**FINAL SUBSEQUENT
ENVIRONMENTAL IMPACT REPORT**

Skyline Wesleyan Church at Rancho San Diego

**SPA 94-001
MUP Mod P88-039-W
MUP 95-001
R 94-005
TM 5059
Log No. 94-19-10**

August 21, 1996

Figure 1

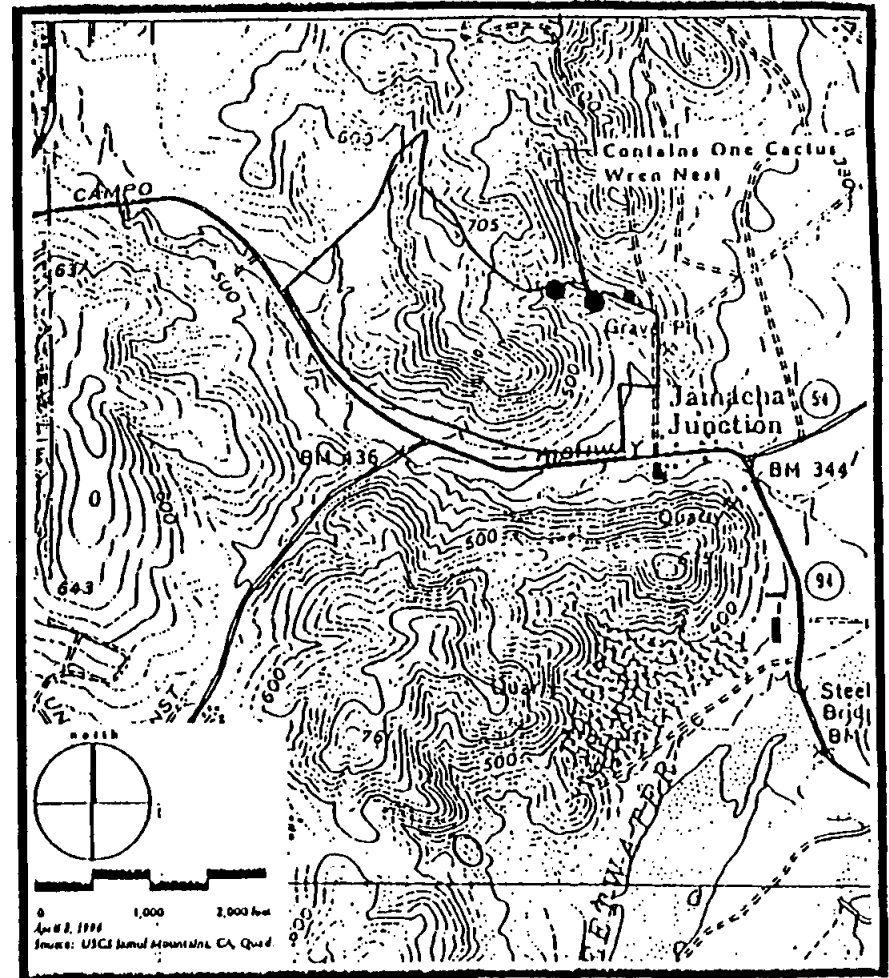
Two cactus stands were located which could provide cactus wren nesting habitat (Figure 1). Both are located near a small drainage which partially parallels the Otay Water District property adjacent to and north of the church site. No cactus wrens responded to the taped vocalizations. One cactus wren nest, which is at least one year old, was found. It was located in the eastern cactus stand.

Relocation of the Offsite Water Line

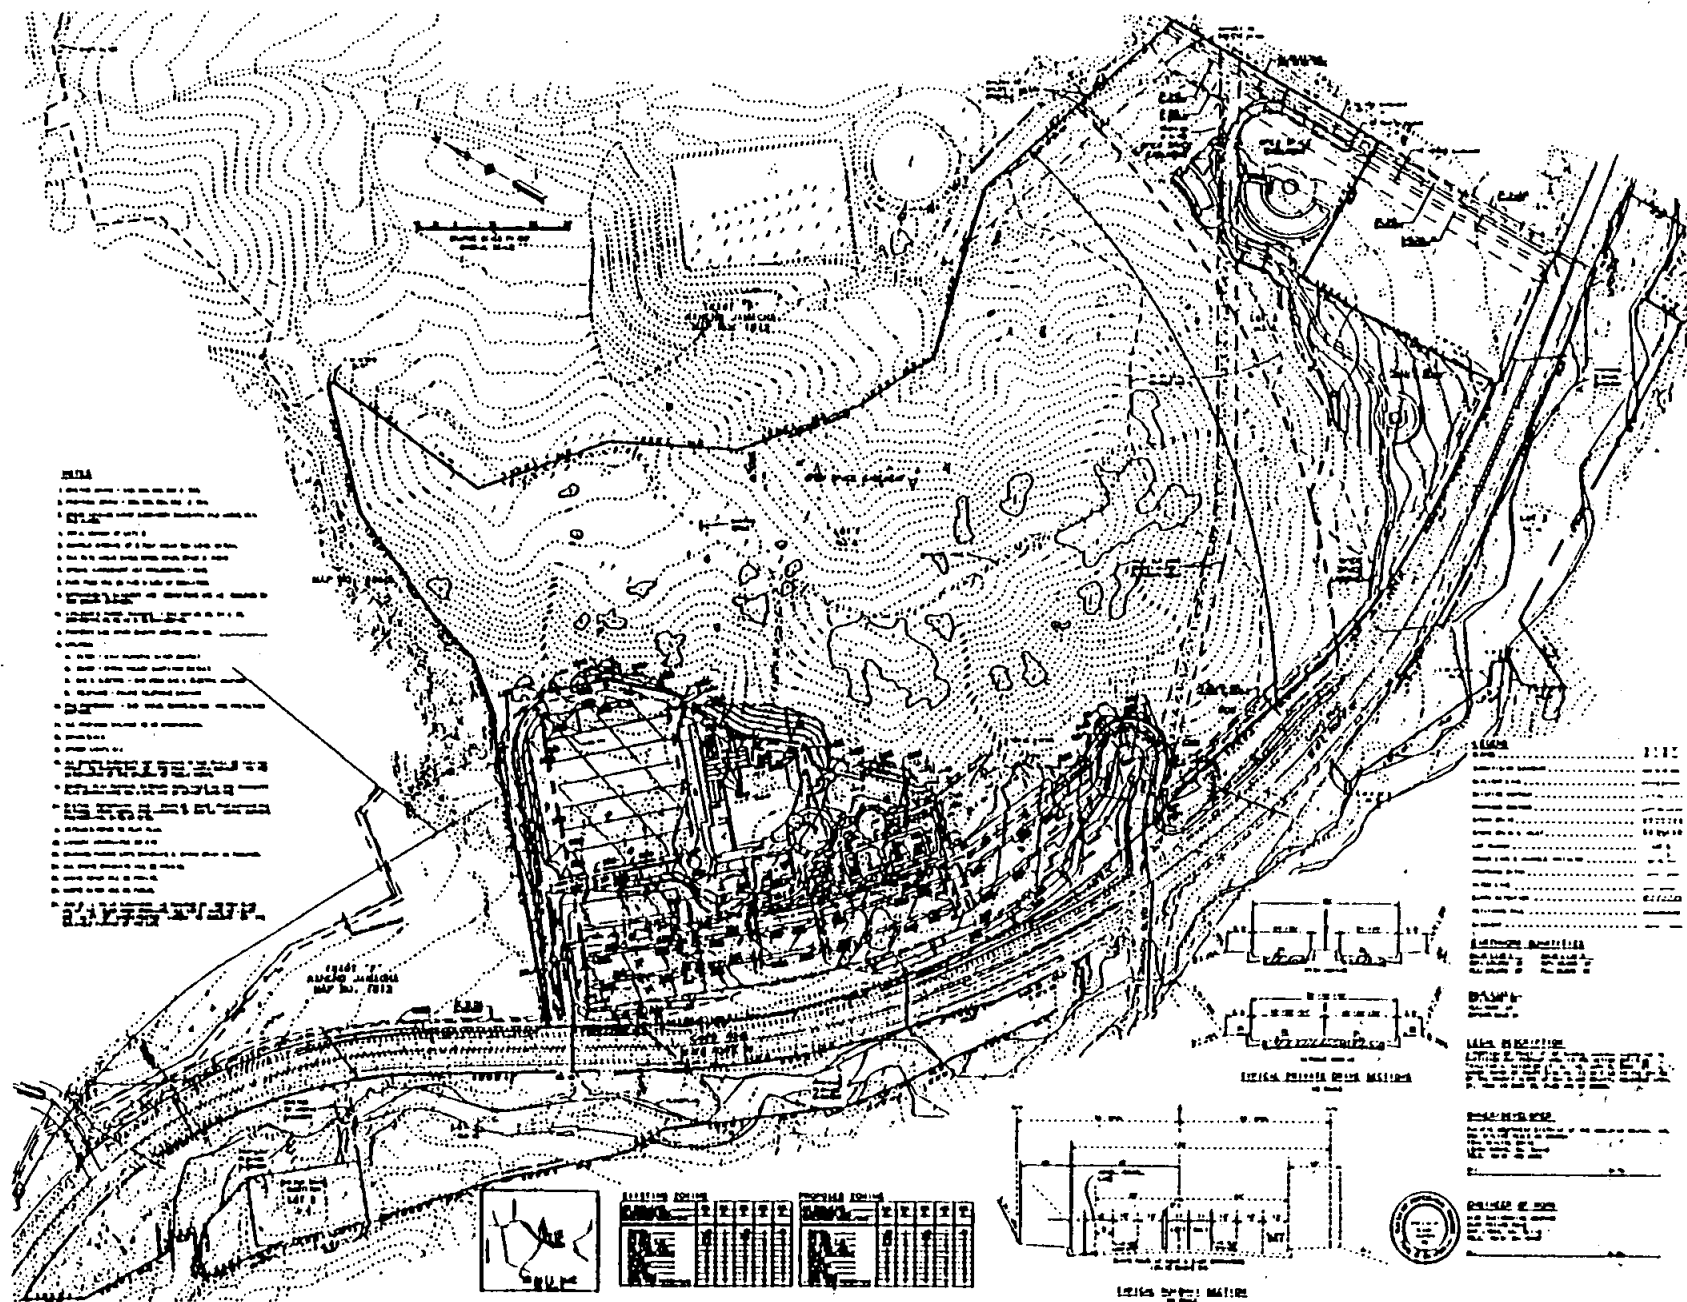
As recommended by the Otay Water District, the project design has been revised to eliminate the water line along the western project boundary which extended offsite from the northwestern corner of the site to Via Escuda. The revised project would construct a 12-inch offsite water line within a 20-foot water easement adjacent to the north side of Campo Road, extending offsite for approximately 1200 feet from the western project driveway to the existing 12-inch water line in Via Mercado. Exhibit C illustrates the revised location of the offsite water line and the area of disturbance associated with the new water line. The area of additional disturbance for the relocated offsite water line ranges from approximately 25 feet along the eastern portion of the line up to a maximum of 45 feet along the western portion of the water line. A ten-foot-high cut slope would be created north of the western portion of the relocated water line.

Figure 4.5-1

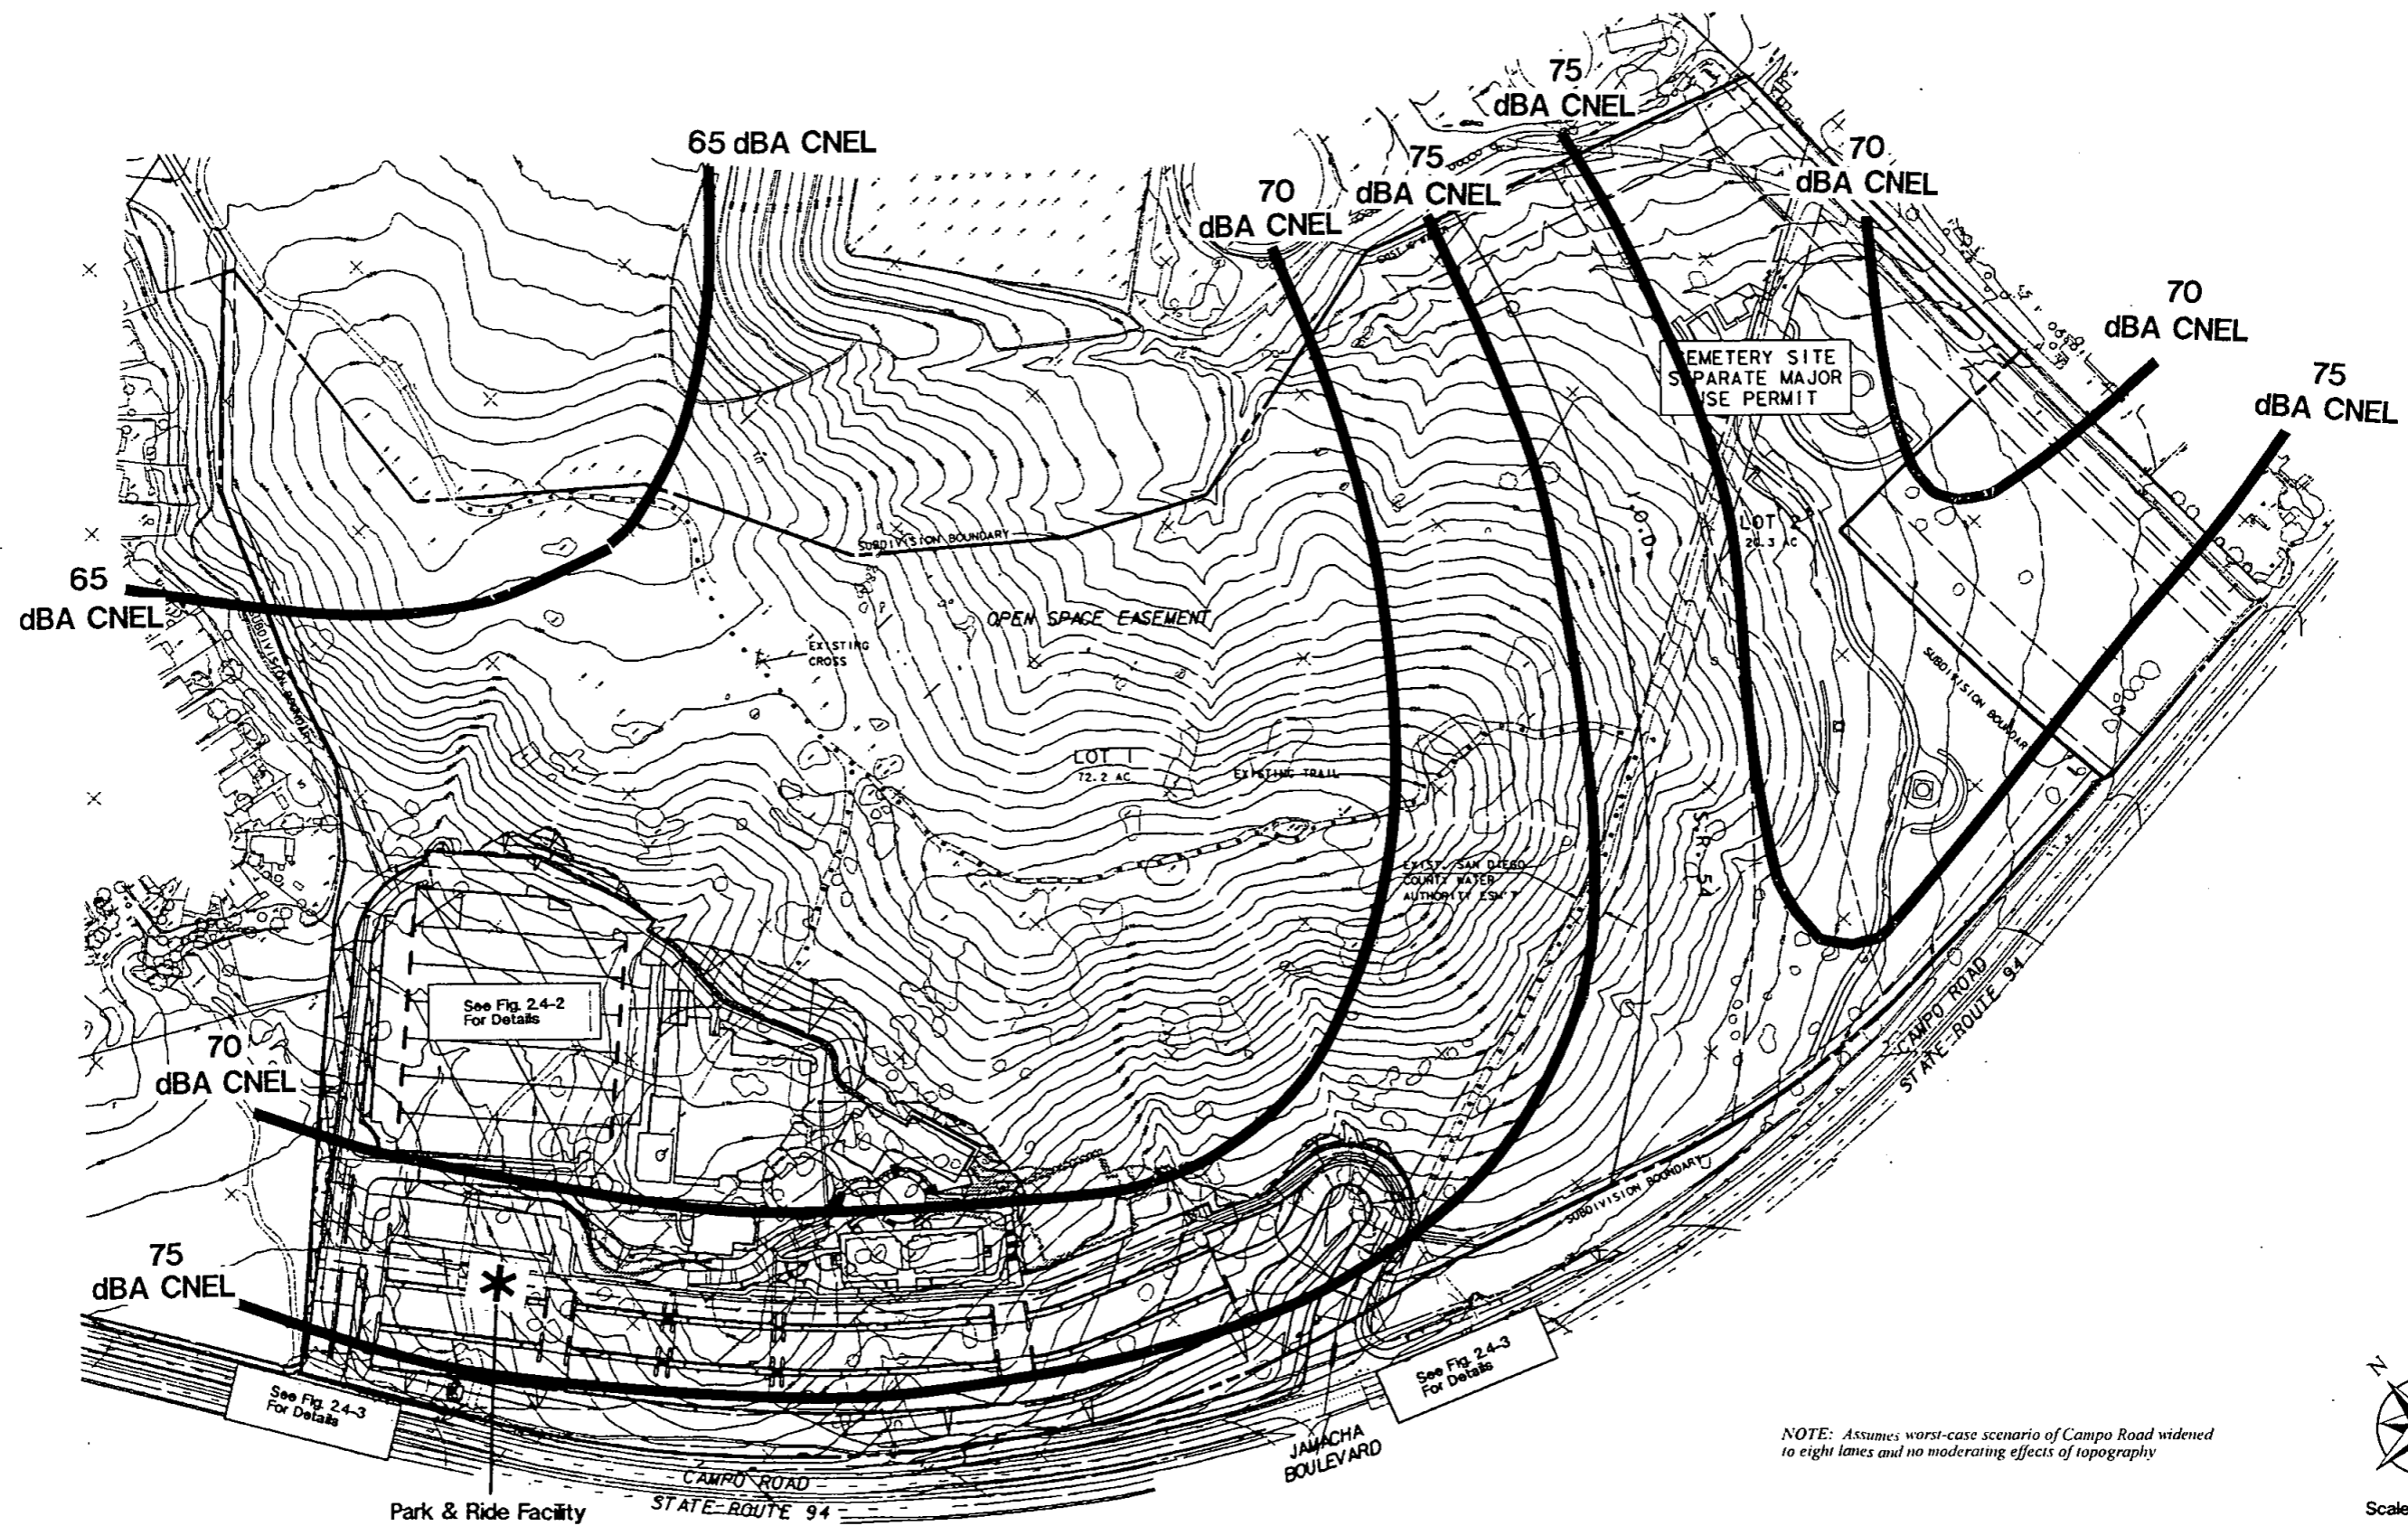
3. The proposed Park and Ride Facility (figure 4.5-1) will encourage more car thieves into the area, and in general raise the crime rate which in turn impacts the public services.

4. Authorize a more detailed EIR section regarding the Park and Ride Facility (figure 4.5-1) and the impacts it will have on the community.
